HOMES FOR GOOD HOUSING AGENCY 100 W. 13th Avenue, Eugene, Oregon 97401

ADDENDUM NUMBER TWO Project #20-C-0048

Pengra Court Exterior Improvements Springfield, Oregon

January 4, 2021

COVER SHEET

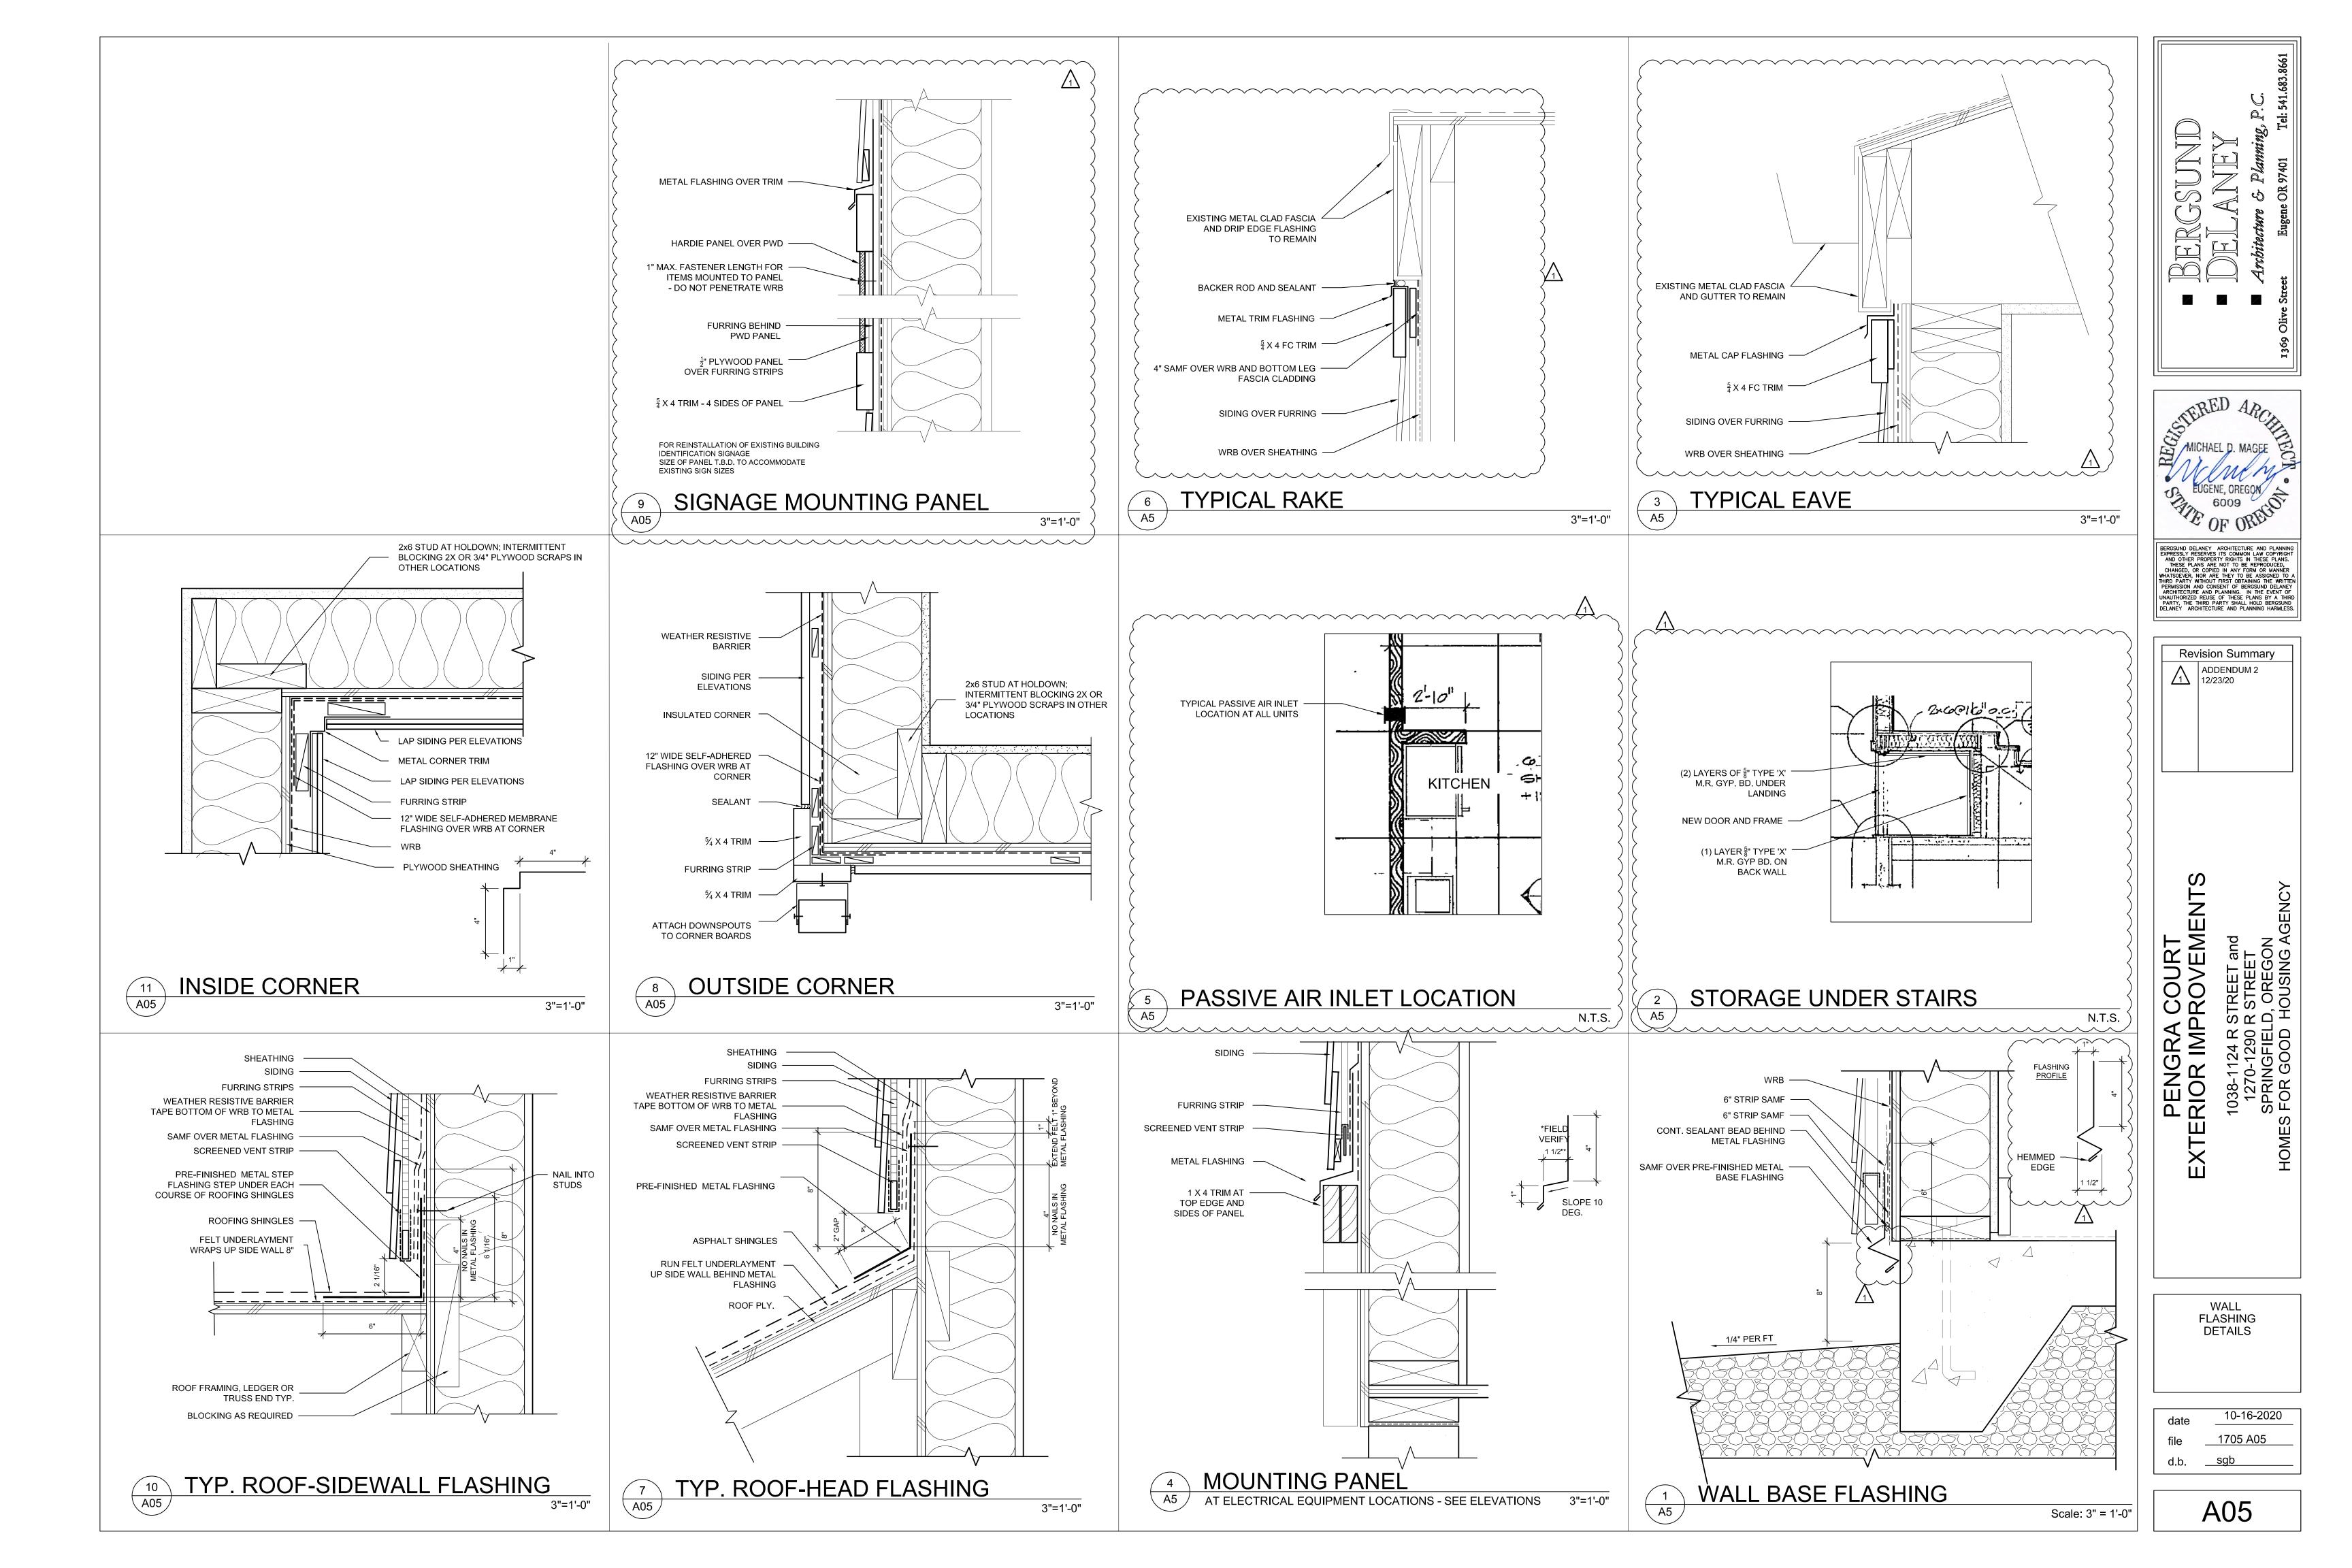
- 1. Sheet A01
 - a. Under "ENVELOPE WORK", note that sheathing replacement allowance is changed to 10% of total wall area.
 - b. Rainscreen battens are described in specification, are not plywood, and are approx. 3/8" thick.
 - c. Passive Air vents reduced to (1) per unit.
 - Storage room doors under stairs are changed to fiberglass doors with composite frames in lieu of specified plywood.
 - e. Mounting panel detailed on sheet A05 for reinstallation of existing building signage.
 - f. All windows to get full trim per window details, whether currently existing or not.
 - g. Replace interior trim and back patio doors to match adjacent windows.
 - h. Interior of storage under stairs requires installation of moisture resistant gyp bd. to provide 1-hr. fire separation from unit interior.

• Replace all damaged sheathing where occurs and replace with new plywood of same thickness. Where sheathing is replaced, inspect and repair damaged framing as needed. Assume an allowance of 10% of total exterior wall area for repair/replacement of damaged sheathing and/or framing.

3. Install (2) (1) passive air vent for each unit. (as shown in drawings)

Replace existing plywood storage doors to areas under stairs with new custom size fiberglass door with composite frame.

• at under stair storage areas, install (2) layers of $\frac{5}{8}$ " type 'x' Moisture Resistant gyp. bd. to underside of stair landing and (1) layer to storage side of landing support wall for 1-hr. rated separation from adjacent living space.
